**NRC ADVANCED MANUFACTURING PROGRAM (AMP)
WINNIPEG, MB**

<u>Contents</u>	<u>No. of Pages</u>
Addendum No. 5	89
<u>Attachments:</u>	
Specification Section 03 35 50 Concrete Floor Finishing	3
Specification Section 07 52 00 Modified Bituminous Roofing Membrane R1	7
Specification Section 08 39 53 Blast Resistant Steel Doors and Frames	3
Specification Section 22 15 00.R1 Laboratory Gas Systems	8
23 06 40.13 Silencer Schedule	1
23 06 80.13 Cabinet, Fan Coil, and Unit Heater Schedule	2
DA-099 – PARTIAL A106 – PLAN – LEVEL 1 - WEST	1
DA-100 – 6/A800 – INTERIOR ELEVATIONS	1
DA-101 – PARTIAL A202 - RCP - LEVEL 1 - WEST	1
DA-102 – PARTIAL A203 - RCP - LEVEL 1 - EAST	1
DA-103 – 19/A850 – WASHROOM	1
DA-104 – 25/A850 – WASHROOM	1
DA-105 – Partial A106 – Plan – Level 1 – West	1
DA-106 – 2/A301 – West Elevation	1
DA-107 – 2/A601 – Plan Details – West	1
DA-108 – 3/A601 – Plan Details – West	1
DA-109 – 12/A601 – Plan Detail – West	1
DA-110 – 18/A601 – Plan Details – West	1
DA-111 – A351 – Window Type Schedule	1

1 BASE PLATE 'BP15' & PILASTER 'PL17'
DS.021 | DS.022 SCALE: 1 : 10

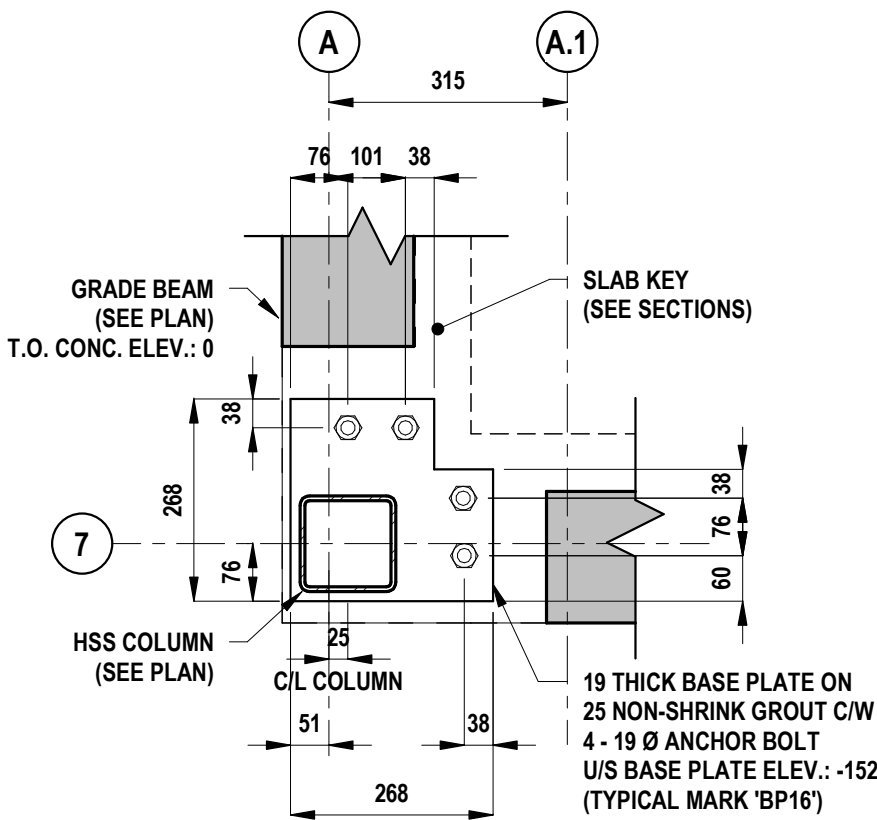
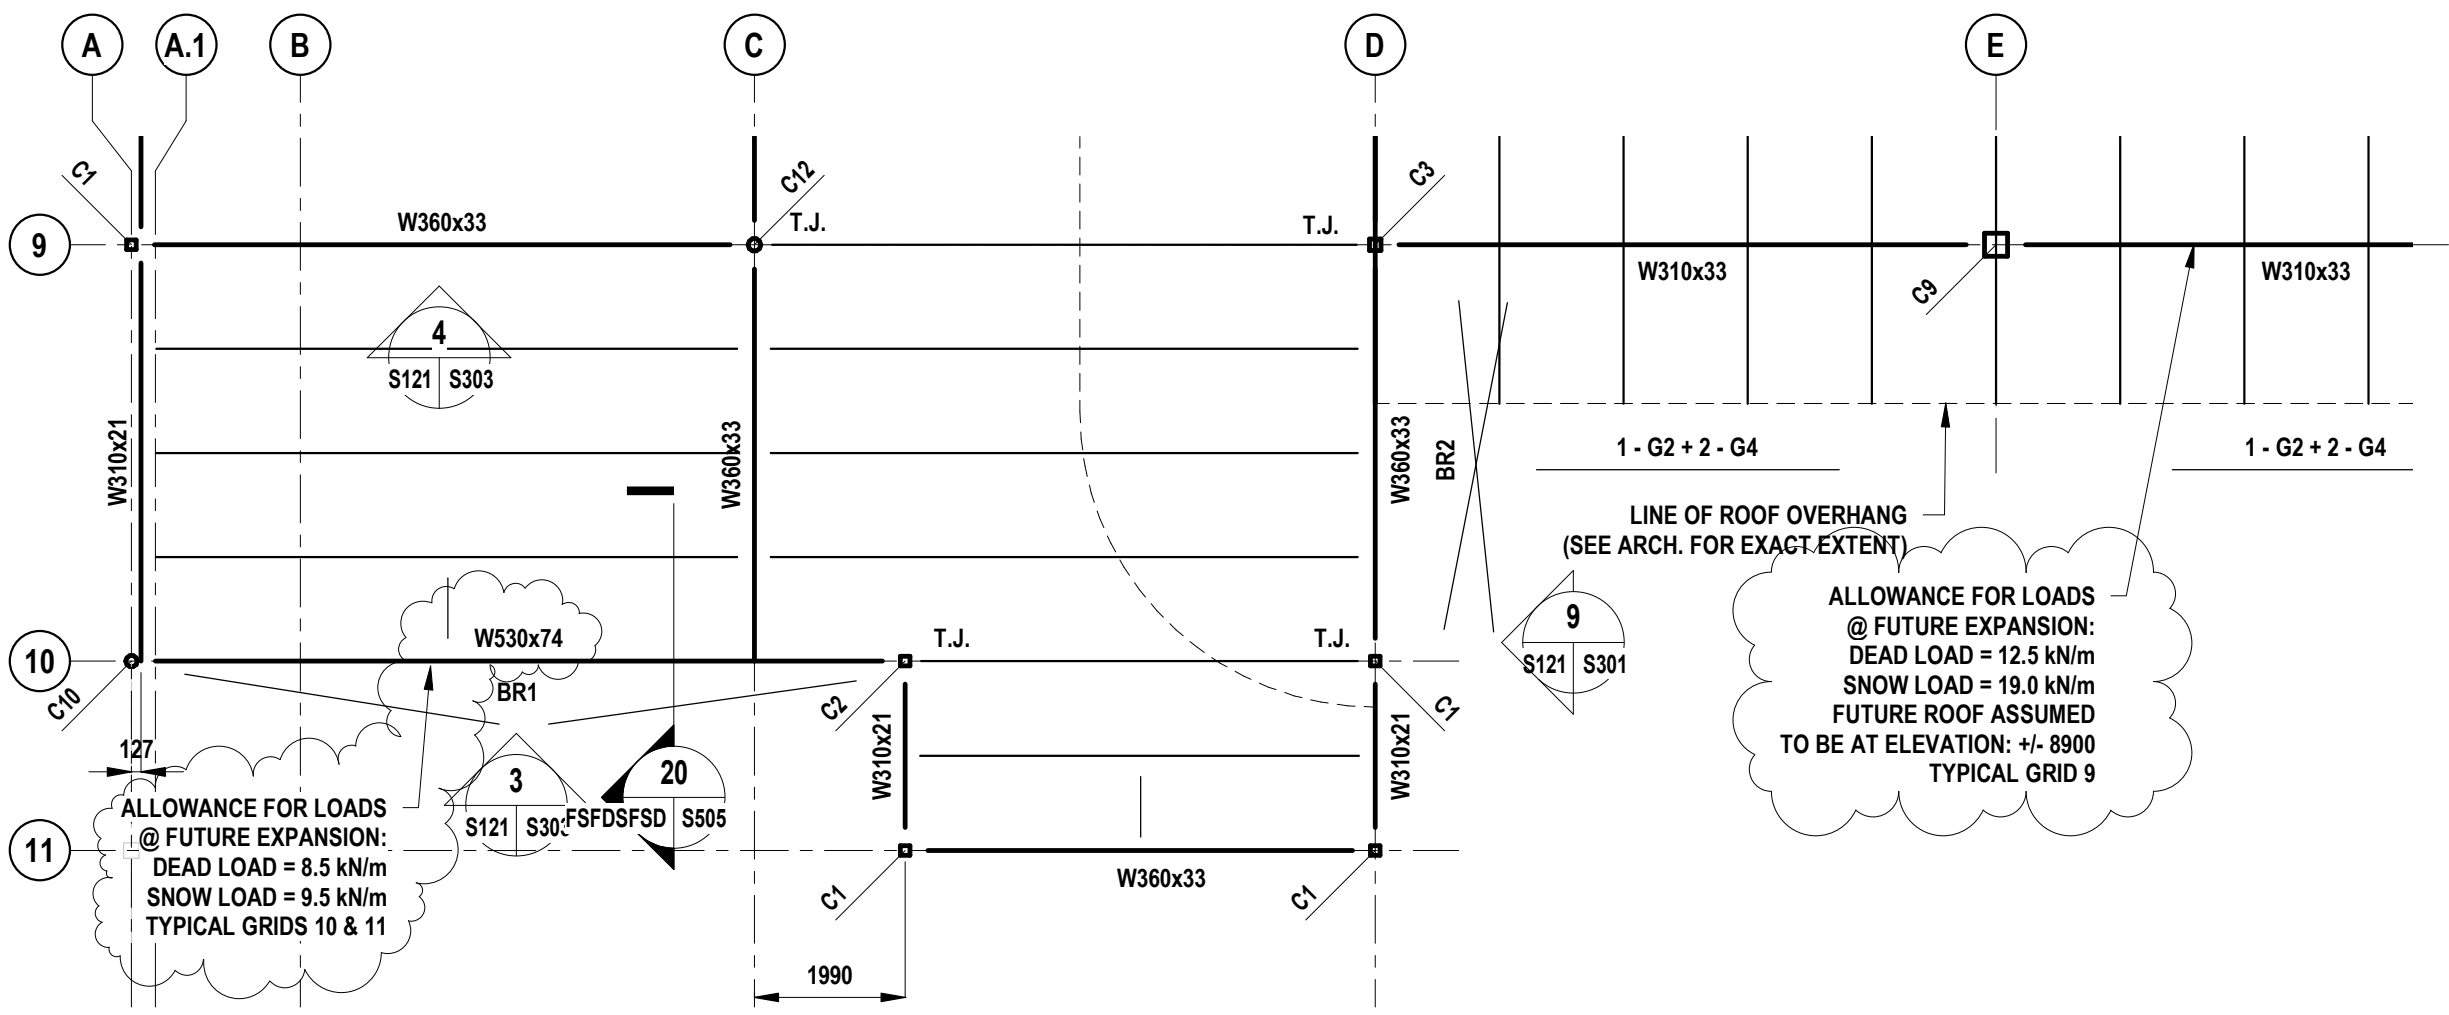
- 7.1 Refer to Drawing S101, S102:
.1 Refer to attached detail sheets DS.015, DS.016, DS.017 and DS.018 for foundation revisions.
- 7.2 Refer to Drawing S121:
.1 Refer to attached detail sheet DS.021 for relocation of grade beams on grids 3 and 7 and addition of base plates and pilasters for columns on grid A/A.1.
.2 Refer to attached detail sheet DS.022 for new base plate and pilaster details.

1 PARTIAL LEVEL 2 FLOOR FRAMING PLAN - WEST

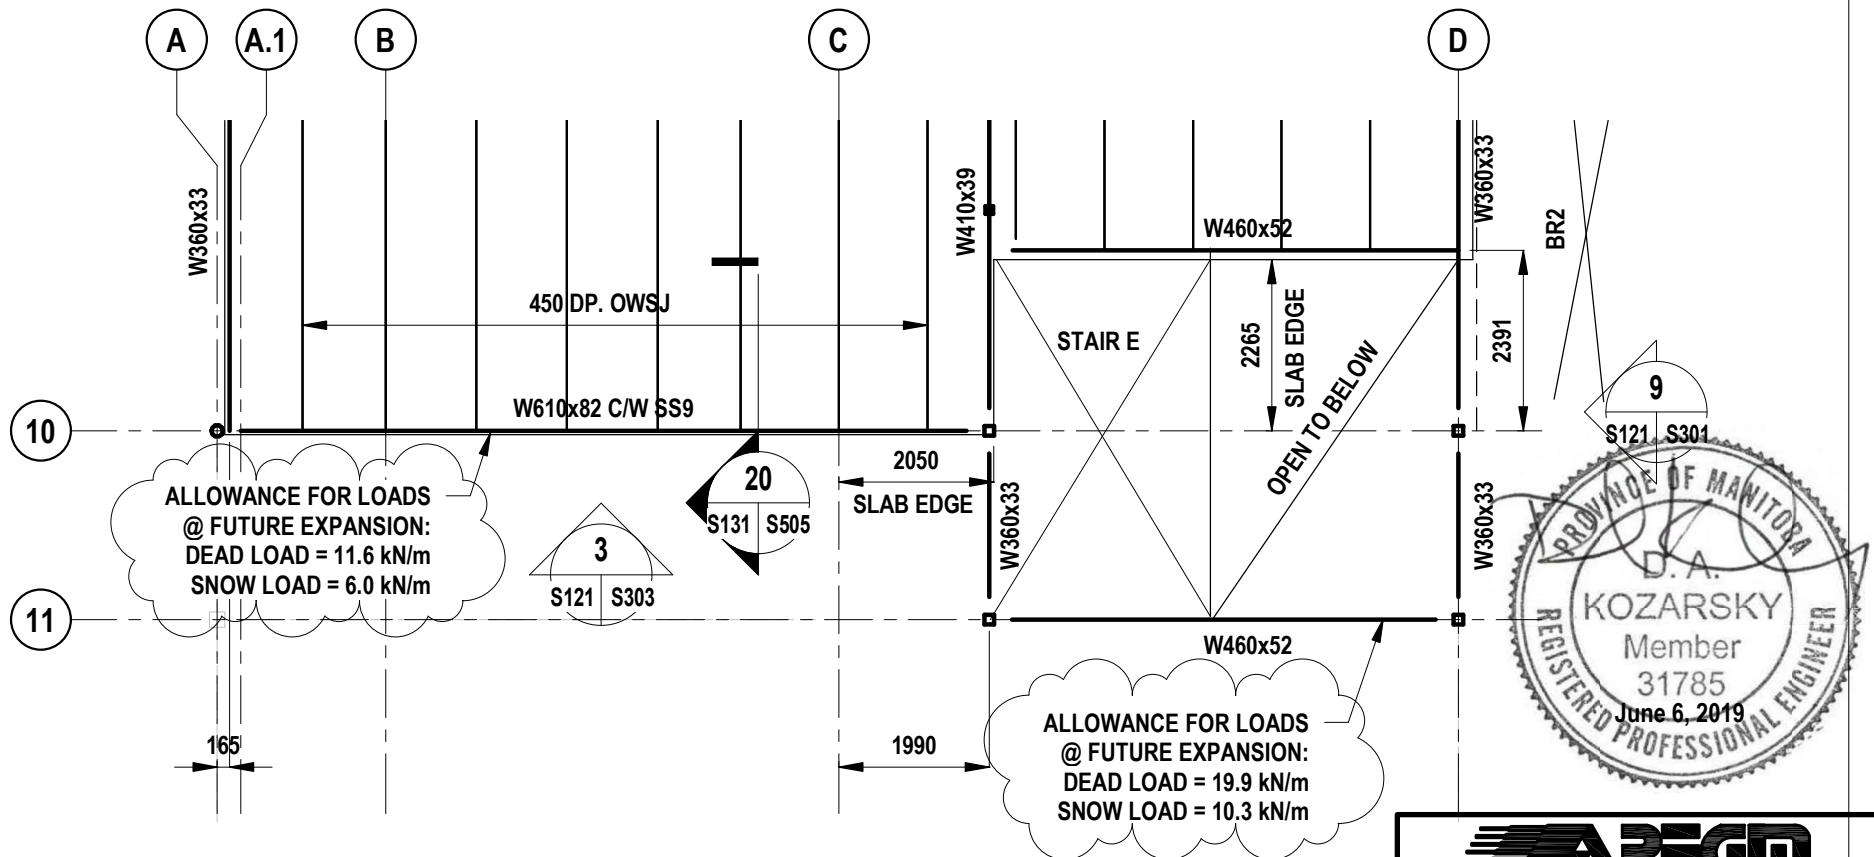
- 7.3 Refer to Drawings S121, S122:
.1 Refer to attached detail sheets DS.019 and DS.020 for clarification of loading at future expansion on Level 1.
- 7.4 Refer to Drawing S131:
.1 Refer to attached detail sheet DS.025 for clarification of loading at future expansion on Level 2.
.2 Refer to Drawing S131; refer to steel beams spanning between grids A.1 and B, from grid 1 to 3; revise beams from C200x17 to W200x31. W610x125 on grid 2 to remain as is.
